We would like to inform you about the change in the design of linear modules from the following families: 550lm per 1ft, 1100lm per 1ft, and 2000lm per 1ft. The modifications include:

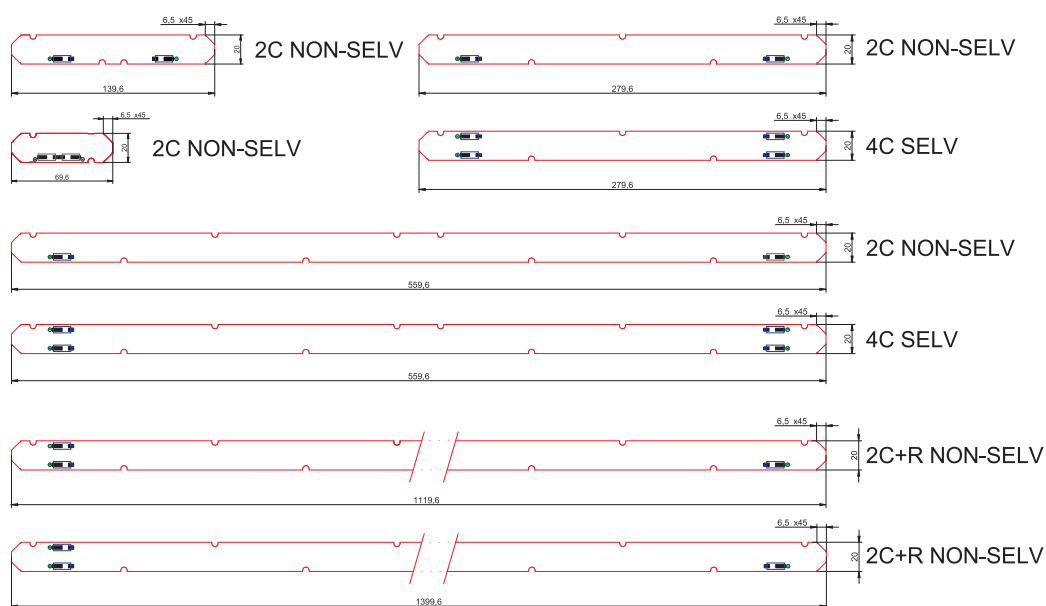
- adding chamfers at the corners
- changing the length tolerance to + 0mm / -0.4mm
- limiting the number of mounting holes to the level specified in the Zhaga standard
- unifying the PCB thickness to 1mm (for 1120mm-4ft and 1400mm-5ft)
